PLANNING COMMISSION MEETING

LOCATION: TOWNSHIP ANNEX, 7527 HIGHLAND ROAD, WHITE LAKE, MI 48383
THURSDAY, SEPTEMBER 05, 2024 – 6:30 PM

**WHITE LAKE TOWNSHIP
PLANNING COMMISSION
AUGUST 15, 2024**

Table with 2 columns: SCALE, SHEET NO. Includes SCALE: NONE and SHEET NO: C0.01.

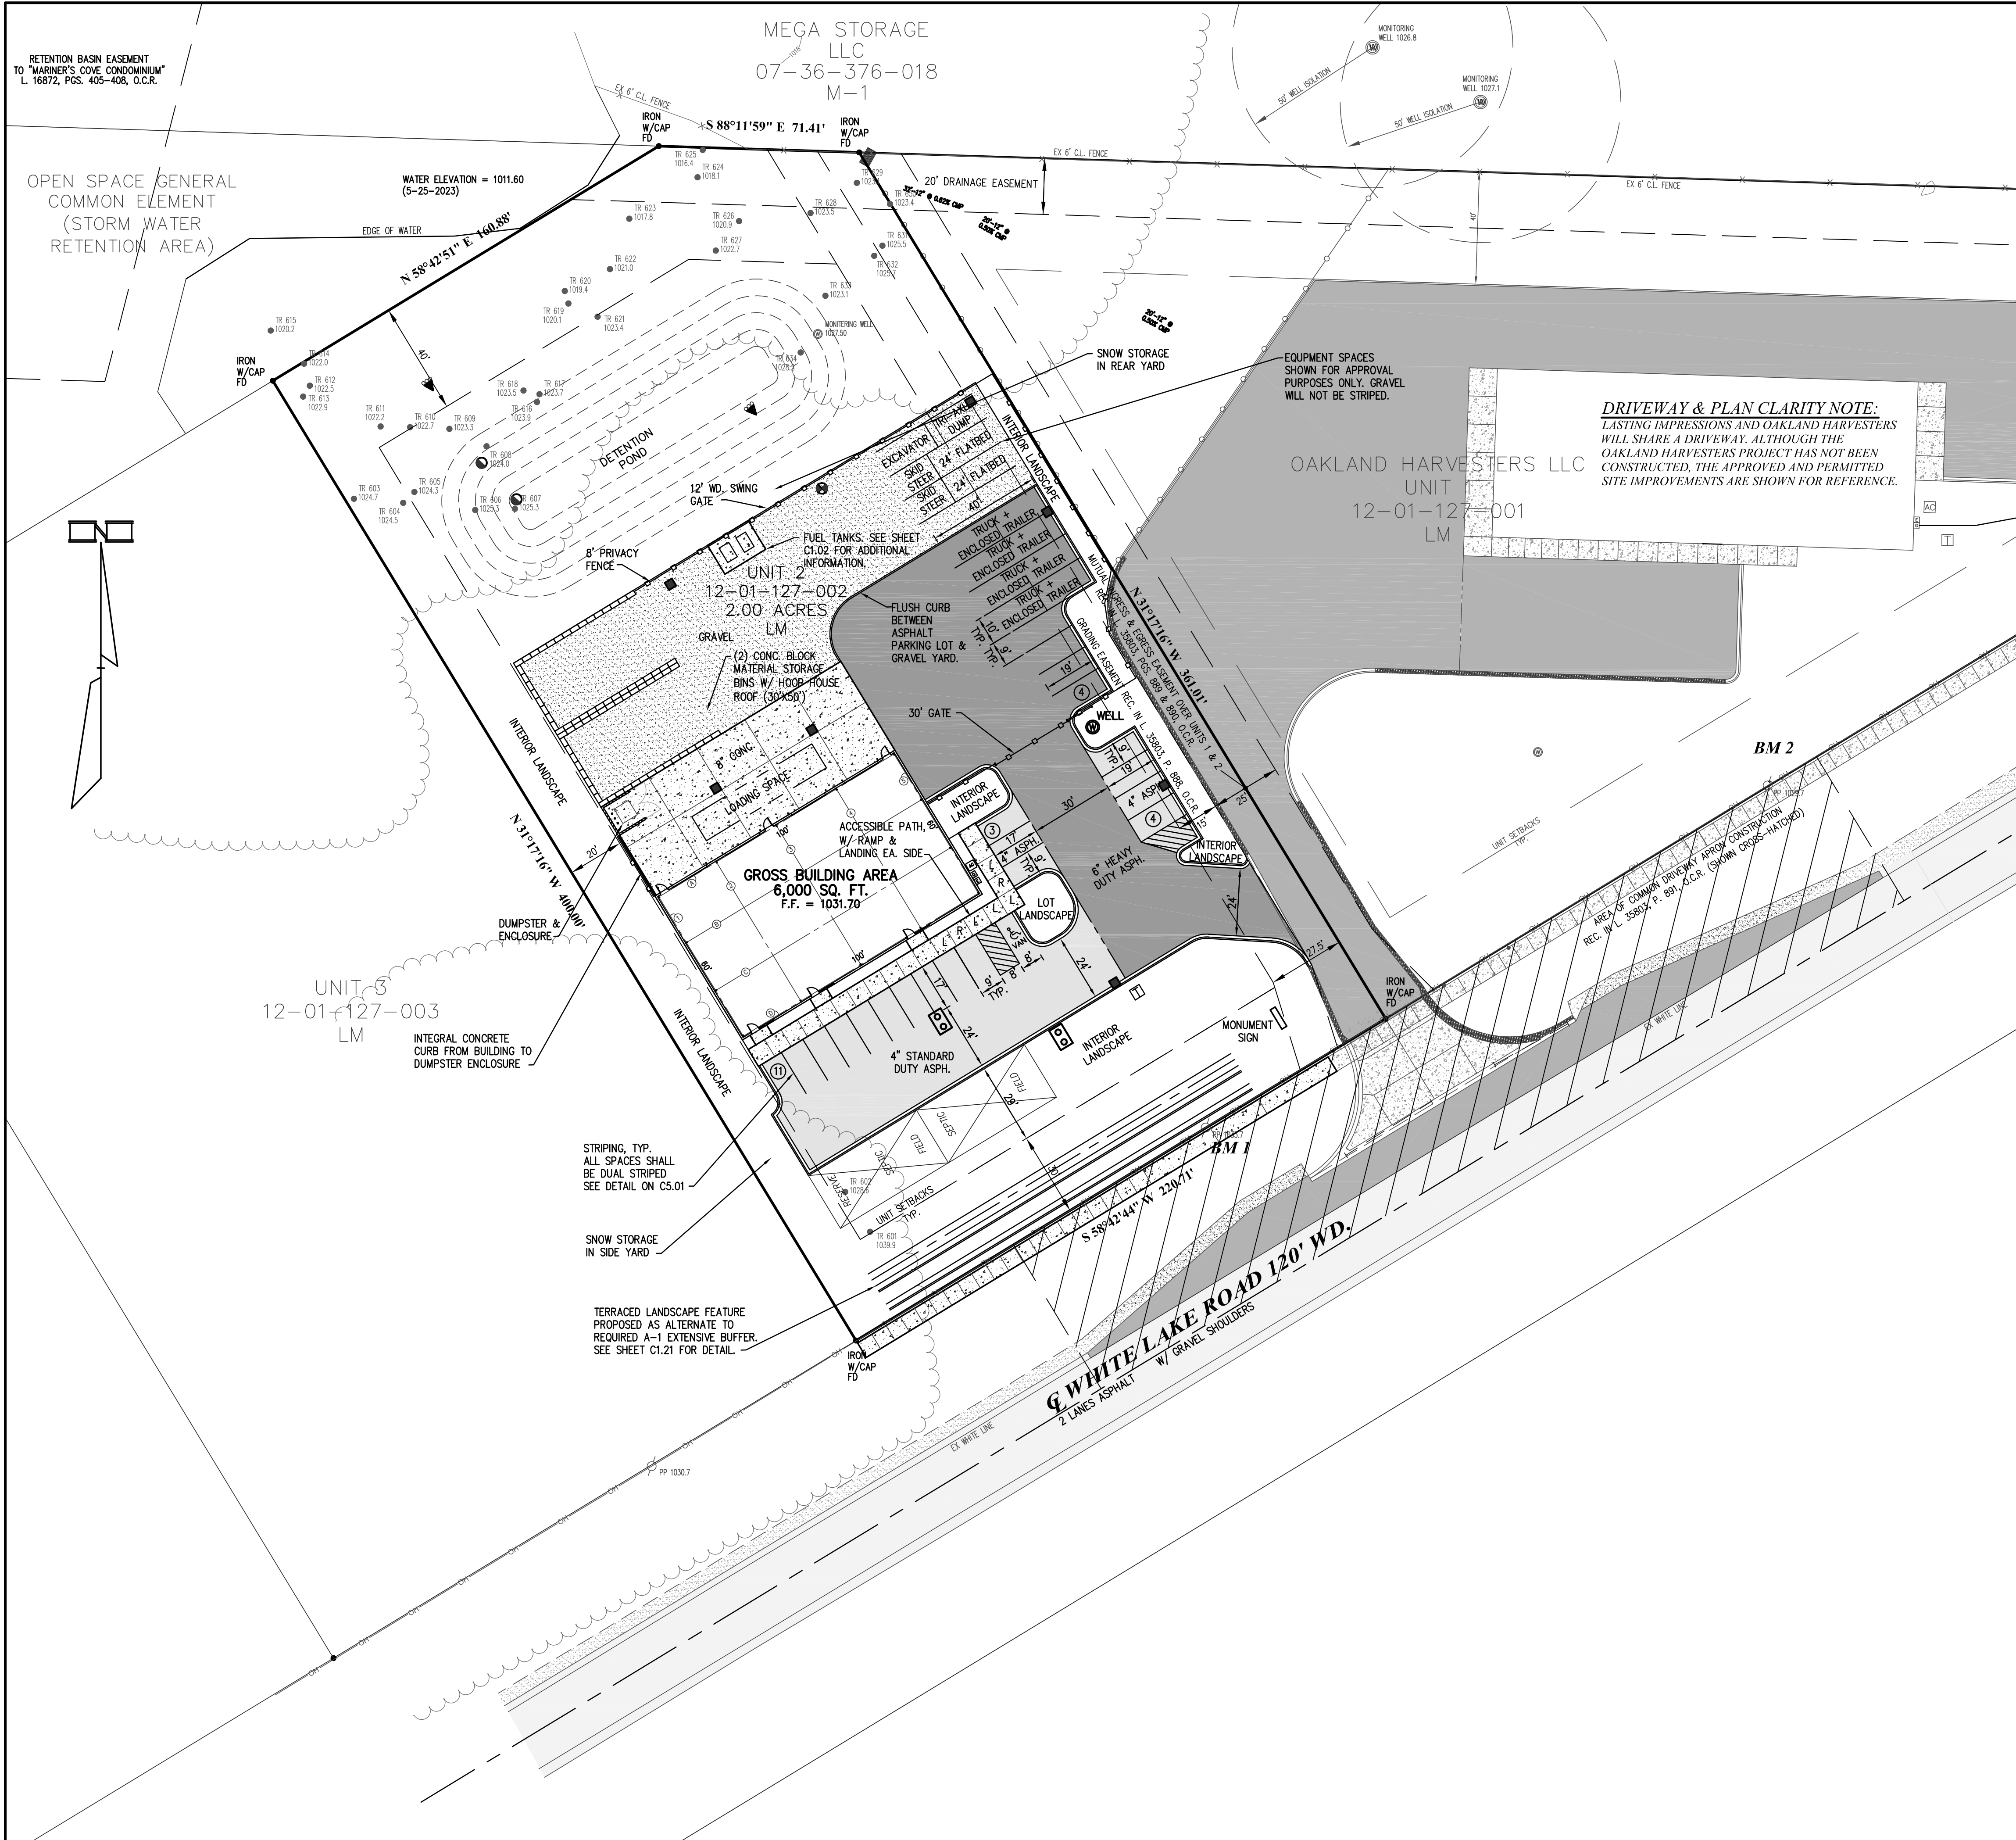
4. *Sheet C0.01- Utilities notes- Item 1- Revise minimum cover to the following: a) Water- 6.0' except at GV's which are 5.5'; b) Sanitary Sewers- 4.0'; All Others (Storm Sewer)- 3.5'-5.0' measured from rim to top of pipe. **Comment addressed. Minimum cover depths have been updated.***

5. *Sheet C.0.01- Utilities notes- Item 6- Provide sheet reference number if underdrain is proposed and provide a detail. **Comment remains. Design engineer states that sheet reference will be filled in on the final engineering plan set.***

SCALE:	1" = 30'
SHEET NO:	C1.01
KE	2023.104

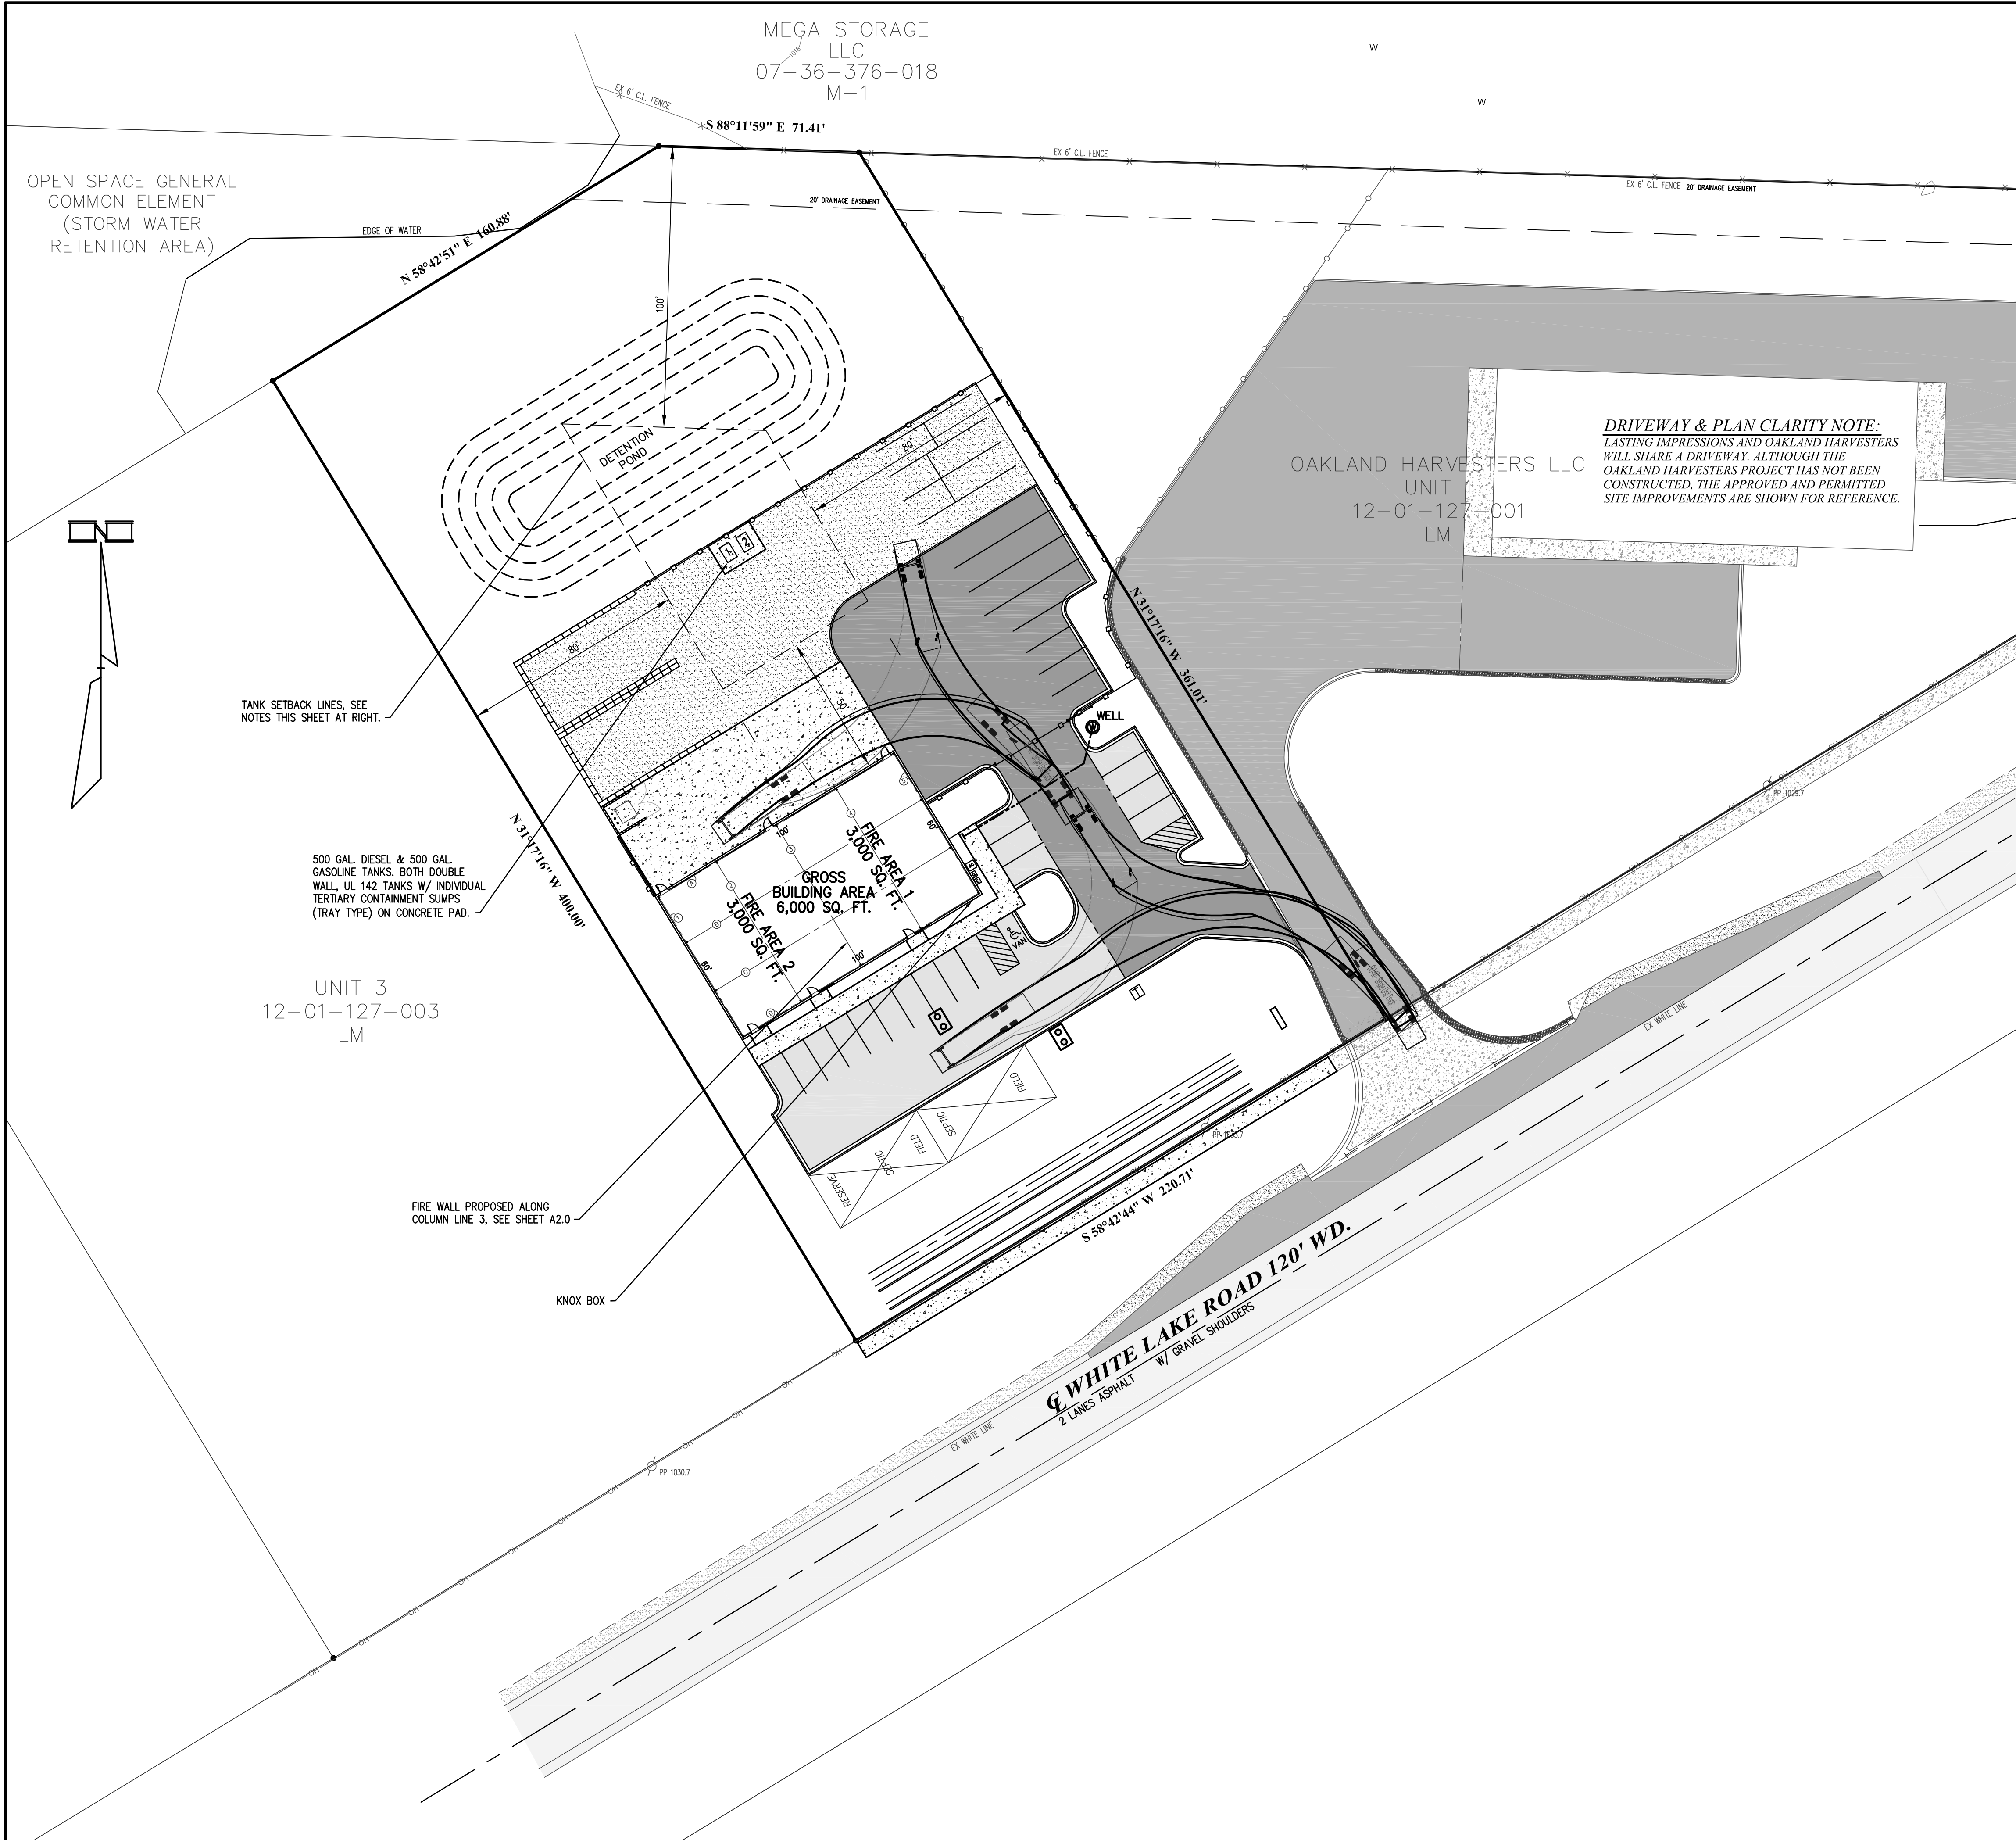
6. *Sheet C1.01- Per Township Zoning Ordinance 5.11.O.iii., at least one ADA parking space shall be van accessible with an 8' wide adjacent loading space. Currently a 5' wide loading space is shown adjacent to the ADA van accessible space. **Comment addressed. The ADA loading space is now shown as 8' wide.***

7. *Sheet C1.01- Provide dimensions for the four (4) parking spaces adjacent to the truck and enclosed trailer parking. **Comment addressed. Dimensions have been provided.***

8. *Sheet C1.01- Label the surfacing material for the northern storage area and excavator/ skid steer parking area as gravel on this plan sheet. **Comment addressed. Surfacing material has now been specified.***
9. *Sheet C1.01- Is curbing intended for the area to the west of the proposed loading space? Plan is not clear as to whether curbing is shown here. Curbing shall be required for this area. **Comment addressed. A call-out has been added to this sheet indicating curbing in the above referenced area.***

We note only one area on Sheet C1.01 indicates "lot landscape" and no square footage for the area is provided. A note under the "REQUIRED PARKING LOT LANDSCAPING PER ZO SECTION 5.19G" states 363 square feet of parking lot landscaping is provided. The title for the area on the Sheet should be retitled "Parking Lot Landscape" to correlate between the map title and corresponding notes.

Snow storage information has been added to Sheet C1.01. The front lot will store snow in the west side yard. Rear and side lot snow will be stored in the rear yard. It should be considered that storage of snow in the side yard has the potential to spill into neighboring properties either during freeze or thaw conditions. We propose consideration of retaining all snow storage to the rear yard location.
